Technical Service Bulletin

60 Sunroof frame modification

60 24 72 2065731/4 July 17, 2024. Supersedes Technical Service Bulletin Group 60 number 23-65 dated April 7, 2023 for reasons listed below.

Figure 2. Front sunroof glass panel side skirt protrusion from an unmodified water guidance washer.

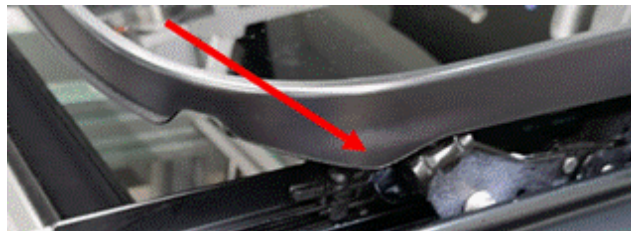
1. If the sunroof frame and/or front sunroof glass panel require replacement the water guidance washer on the sunroof mechanism pivot protrudes to the extent that the rubber “skirt” on the front glass panel also protrudes creating interference between the glass panel and the sunroof opening. This interference can prevent the front glass panel closing sequence from completing.
2. Figure 2 shows the location of the “skirt” protrusion from the water guidance washer.

Figure 1. The front sunroof glass panel side skirt is deformed due to a protruding water guidance washer.

4. Remove the front sunroof glass panel. Using a small pair of diagonal cutters (side cutters; Figure 4) trim away the water guidance washer. The washer must be cut back such that it protrudes no greater than the pivot pin. Perform this operation to both sides.
